ADDENDUM 005

DATE: September 20, 2019
ADDENDUM NUMBER: 005
DG PROJECT NUMBER: 3050
PROJECT NAME: APS Coyote Willow Family School – Phase 2
PROJECT ADDRESS: 7125 Irving Blvd NW, Albuquerque, NM 87114
ISSUED BY: Wendy E.S. Caruso, AIA, Project Manager

SHEET NUMBER:
M101

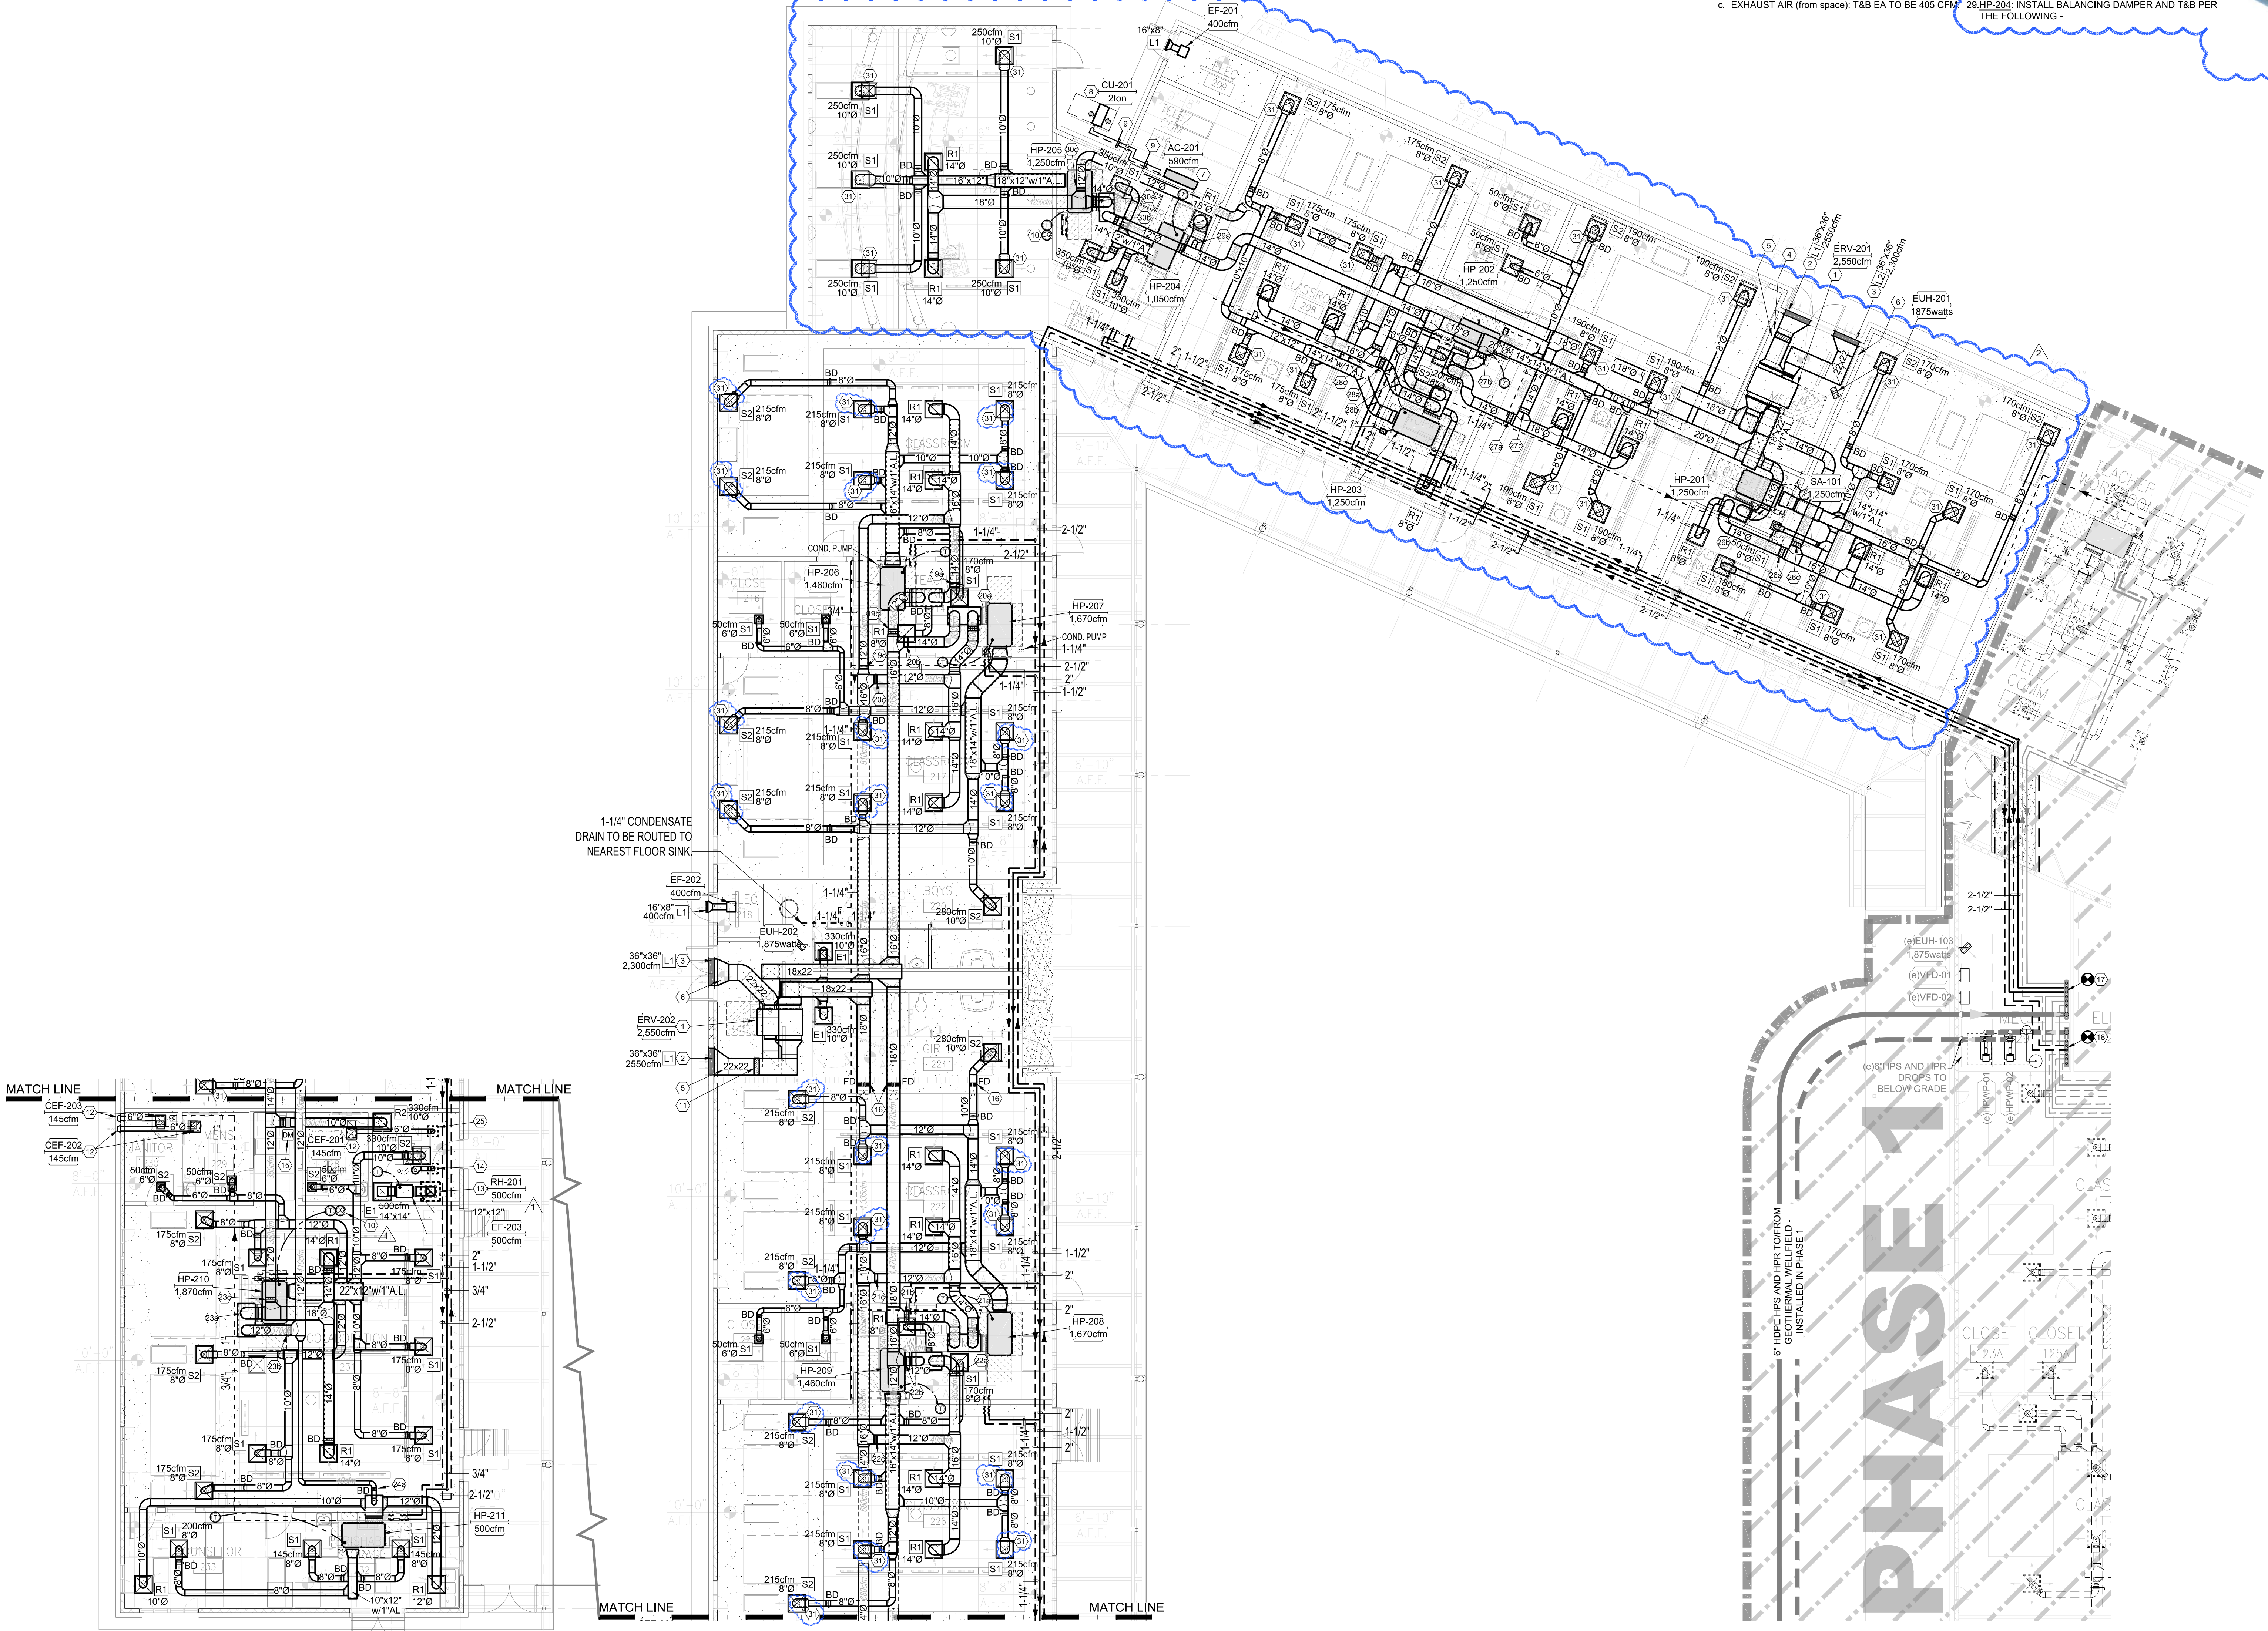
1. ADD: Sound Attenuator Device at all Supply Diffusers in all Classrooms, and Lecture Room. (Keyed Note #31).
2. REVISES: Duct work layout on north side of building.
3. Replace Sheet M101 in its entirety.

a. RETURN AIR (to hp-unit); T&B RA TO BE 690 CFM.
b. OUTSIDE AIR (to hp-unit); T&B OA TO BE 60 CFM.
c. EXHAUST AIR (from space); T&B EA TO BE 515 CFM.
31. PROVIDE / INSTALL "FLEXIBLE" SOUND ATTENUATOR AT CONNECTION BETWEEN DUCTWORK AND SUPPLY AIR DIFFUSER.

a. SOUND ATTENUATOR SHALL BE SAME SIZE AS DIFFUSER COLLAR.
b. SOUND ATTENUATOR SHALL BE CONFIGURED IN FIELD FOR 90° ELL (APPROX.).

SHEET NUMBER: M501

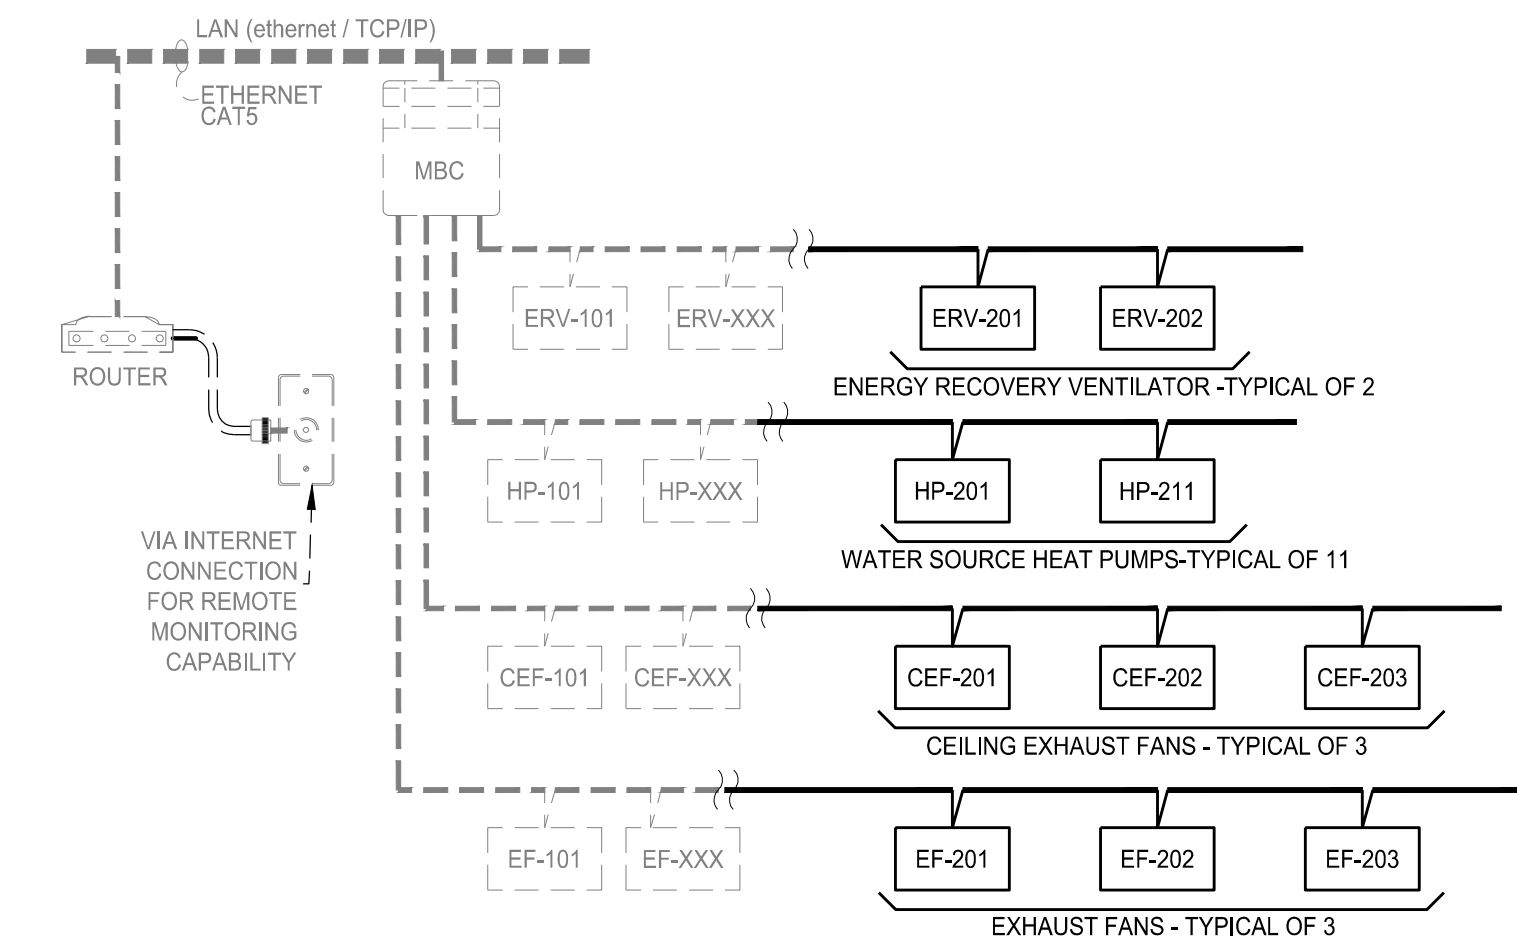
4. ADD: Clarification note in regard to existing BAS/ DDC system.
5. Replace Sheet M501 in its entirety.

NOTE: 1. THE EXISTING BAS / DDC SYSTEM IS AN ALERTON BAC6000 BAS / DDC SYSTEM. 2. THE EXISTING BAS / DDC SYSTEM WAS INSTALLED DURING PHASE 1 CONSTRUCTION. 3. SCOPE OF THIS PROJECT IS TO EXPAND EXISTING ALERTON BAC6000 BAS / DDC SYSTEM TO INCLUDE EQUIPMENT INSTALLED DURING PHASE 2 CONSTRUCTION. ANY EQUIPMENT CONNECTED TO BAS / DDC SYSTEM MUST BE COMPATIBLE WITH EXISTING ALERTON BAC6000 SYSTEM. 4. EXISTING EQUIPMENT INSTALLED DURING PHASE 1 CONSTRUCTION IS SHOWN "FADED-DASHED".
